Date:	26 th August 2024	Application Number:	LU-2023-112105-00; SG-2023-112106-00; NC-2003-112107-00;
Reporting Planner:	Sarah Exley	Site Visit on:	20 th March 2024

Applicant:	NZHG Gisborne Limited
Property Address:	556 – 560 Aberdeen Road, Gisborne
Legal Description:	Lot 2 DP 1585 contained in Record of Title GS2B/162; Part Lot 1 DP 1585 contained in Record of Title GS110/25; Lot 1 DP 1817 contained in Record of Title GS2B/282
District Plan:	Te Papa Tipu Taunaki o Te Tairāwhiti – Tairāwhiti Resource Management Plan
Zoning:	General Residential
Other Restrictions:	Land Overlay 1; Reticulated Services Boundary; Aberdeen Road – Collector Road
Activity Status:	Discretionary
Proposal:	Bundled Land Use and Subdivision consent to enable a 12-unit housing development

Report to Hearings Commissioner

Figure 1. Elevations; orange indicates height recession plane infringements on boundaries. Some are duplex boundaries and so not applicable. Yard infringements not shown.

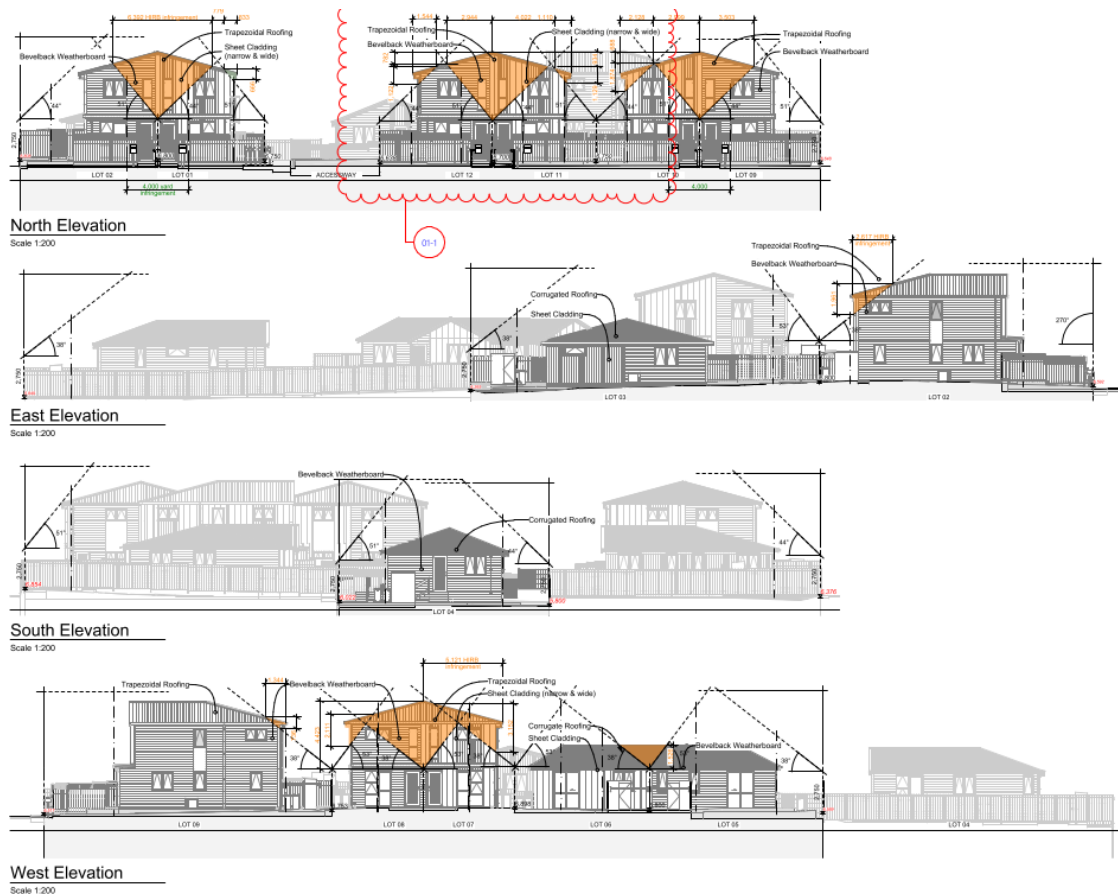
107. However, the Applicant has chosen to reduce the internal yard setbacks and breach required recession planes for internal boundaries. While the Applicant considers that they are able to give themselves approval for these infringements, I consider the effects of them still important to consider for a proposal where the attached dwellings fall short of the required minimum size by more than 50%, and the detached dwellings by more than 25%.

108. Due to the duplex layout, Lots 1, 2 and 5 – 12 will infringe the relative height in relation to boundary recession plane along the common party wall boundary. Additionally, the proposed dwellings will infringe the recession planes to the internal boundaries as follows:

Figure 9. Snip of proposed 24% site coverage landscaping.

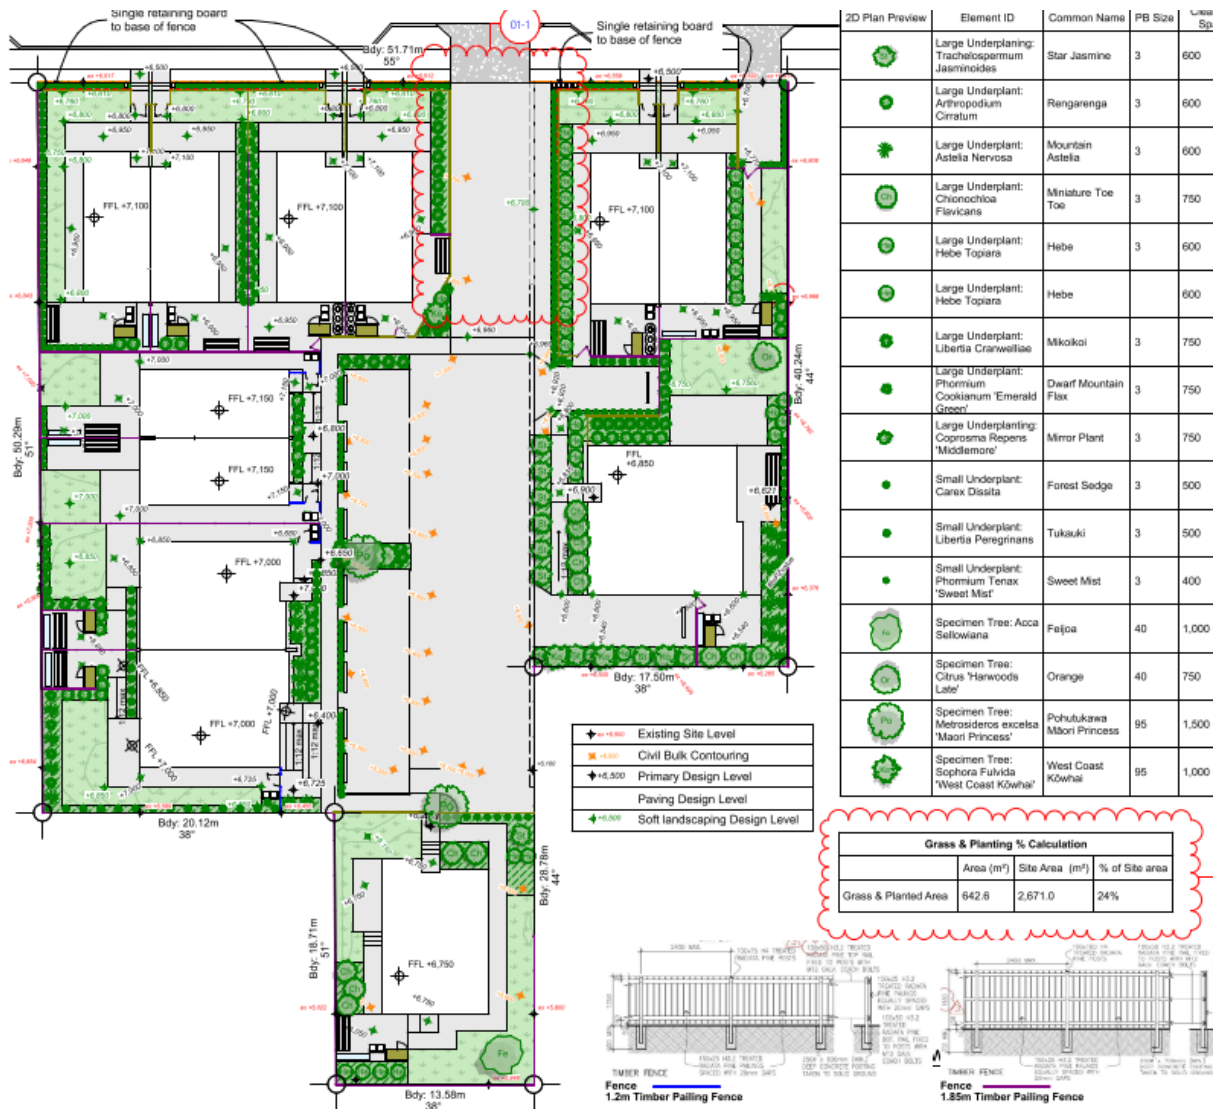
145. The Applicant has submitted a landscaping plan showing 24% of the site will be planted in various species. This is 642m² of 'grass and planting' in area, compared to over 1,200m² (>47.5%) impervious surface area and 759m² (or 28.4%) total building coverage.

147. It is my understanding that the provision of landscaping is not intended to completely screen developments but instead, is a useful mechanism to help integrate development into the site and/or soften the appearance of the built environment and to assist in maintain or improving visual amenity. In some instances, this requires an integration of larger tree species with smaller growing species. The majority of the proposed species are small ‘underplanting’ shrubs or compact hedging (12 of 16 species do not reach more than 750mm height at maturity). I do not consider the

proposed landscaping will assist to mitigate the effects of combined impervious surface area and dense building coverage. This is because the species proposed within the public/private interface (along the road frontage and between the JOAL and dwelling units) are primarily small, low growing species; and the planting bed widths are in most instances very narrow, which potentially would not facilitate larger growing species to thrive. A wider bed depth provides greater opportunity for variation and better visual integration of the planting to offset the scale of development.

149. I am unable to agree with the Applicant's assessment. The intent of the landscaping is not to completely screen visibility of the buildings however, landscaping should provide a reasonable level of amenity against the bulk and density of the development, not just when viewed from sites external to the property. I do not believe that this can be achieved in a manner which offsets the scale of development nor will the landscaping achieve a similar level of amenity to the present landscaping experienced in the wider environment of Aberdeen Road and the General Residential zone.
